ADA Curb Ramp New Construction Inspection Form (Parallel)

Main	24952.54			Wascoe	
North-South Road Name	Project No.	Sheet No.	Intersection No.	East-West Road Name	See https://www.oregon.gov/odot/Engineering/Documents_RoadwayEng/ADA_ExhibitA.pdf for more corner styles. Use Washington County corner numbering system.
Calibration Date 10/8/2024 (mm/dd/yy)

PARALLEL RAMP (PL)

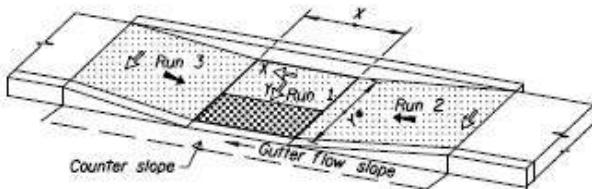
RAMP RUN 1	Pass	Fail
Running Slope 1	2.8 ≤ 2.0% <input type="checkbox"/> > 2.0% <input checked="" type="checkbox"/>	
Cross Slope 1	2.0 ≤ 2.0% <input checked="" type="checkbox"/> > 2.0% <input type="checkbox"/>	
Detectable Warning	Y Y <input checked="" type="checkbox"/> N <input type="checkbox"/>	
Lip Height	0 ≤ 1/4" <input type="checkbox"/> > 1/4" <input type="checkbox"/>	
Gutter Flow Slope	0.8 ≤ * <input checked="" type="checkbox"/> > * <input type="checkbox"/>	
Curb Running Slope (avg)	<input type="checkbox"/> 1.52 ≤ 8.3% <input type="checkbox"/> > 8.3% <input type="checkbox"/>	
Counter Slope (+/-)*2	7.4 ≤ 5.0% <input type="checkbox"/> > 5.0% <input checked="" type="checkbox"/>	
Det. warning full width of ramp	Y Y <input checked="" type="checkbox"/> N <input type="checkbox"/>

RAMP RUN 3	Pass	Fail
Running Slope 3	<input type="checkbox"/> ≤ 8.3% <input type="checkbox"/> > 8.3% <input type="checkbox"/>	
Length 3	7.35 <input type="checkbox"/>	
Cross Slope 3	3.5 ≤ 2.0% <input type="checkbox"/> > 2.0% <input checked="" type="checkbox"/>

IITD gt2. Rr2 is grass. No end of walk barricade.
